Advisory Board on Radiation and Worker Health
National Institute for Occupational Safety and Health

SC&A Review of Remaining Internal Dose Issues for the LANL SEC-0109 Addendum Period (1996–2000)

**Contract No. 75D30119C04183
Document No. SCA-TR-2023-SEC002, Revision 0**

April 12, 2024

Figure 3. Total number of surface contamination surveys and air concentration monitoring results by year for TA-53

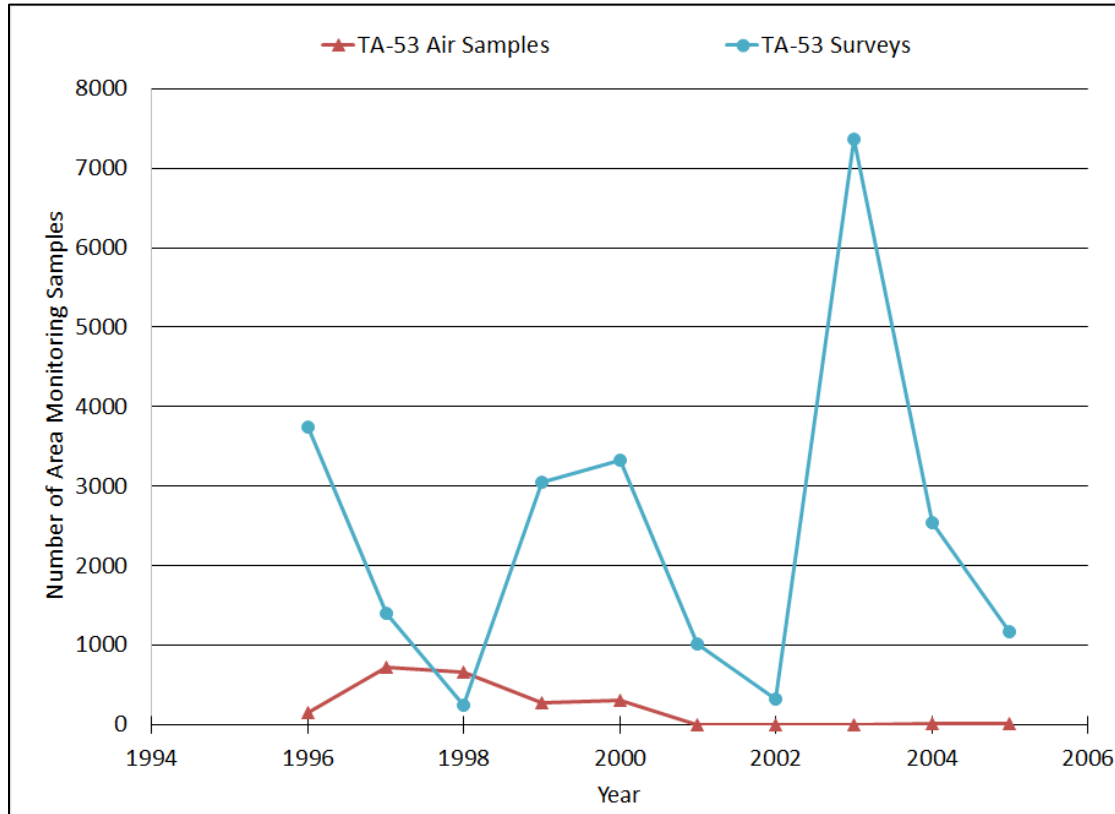
Table 7 presents the number of air sampling results that exceed the 100 mrem limit. As shown in table 7 and figure 3, nearly all of the captured air monitoring records were from 1996 through 2000. The most observed air samples were in 1997 (729) with approximately 22 percent of those exceeding the 100 mrem limit for alpha. Also, in the previous year (1996), nearly one-third of the captured samples exceeded the 100 mrem limit for alpha. After these two years, the number

When parsing the available dataset by year and general TA, nearly all instances showed that 1 percent or less of the data were above the 100 mrem modeled limitation. However, TA-53 in 1996 and 1997 showed that ~33 percent and 22 percent were above the 100 mrem limit. Unfortunately, the building/location-specific analysis in section 2.1.3.3 of this report did not provide further information on these years because the underlying air sampling reports did not specify a location within TA-53. It may be worth further discussion and investigation to determine if the 100 mrem limit is sufficiently bounding for this TA and year (observation 3).
